## REMARKS

A final Office Action was mailed on April 23, 2003. Claims 1 – 11 are pending in the present application. With this Response, Applicants amend the abstract of the disclosure, amend claims 1 – 4, 6, 7 and 9 – 11, and add new claims 12 - 16. No new matter is introduced.

### OBJECTION TO DRAWING

FIG.1  
(PRIOR ART)

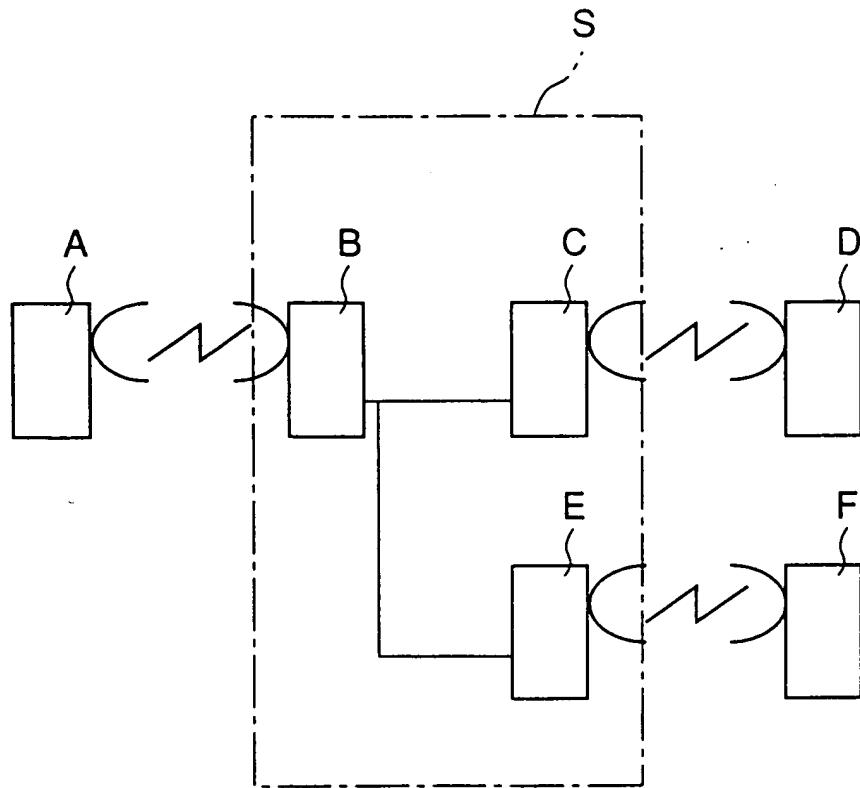
FIGs. 1 and 2 are objected to under MPEP § 608.02g as lacking “Prior Art” legends. FIG. 5 is objected to under 37 C.F.R. § 1.84(p)(4) as using reference character “24” to designate both storage and processor. Proposed drawing changes to FIGs. 1, 2 and 5 to address these objections are provided in both marked-up and clean versions. In FIG. 5, reference character 25 is now used to designate the processor, consistent with Applicants’ description of FIG. 5 for example at page 16, lines 11 – 12 of Applicants’

specification. Accordingly, Applicants respectfully request approval of the proposed changes and withdrawal of the drawing objections.
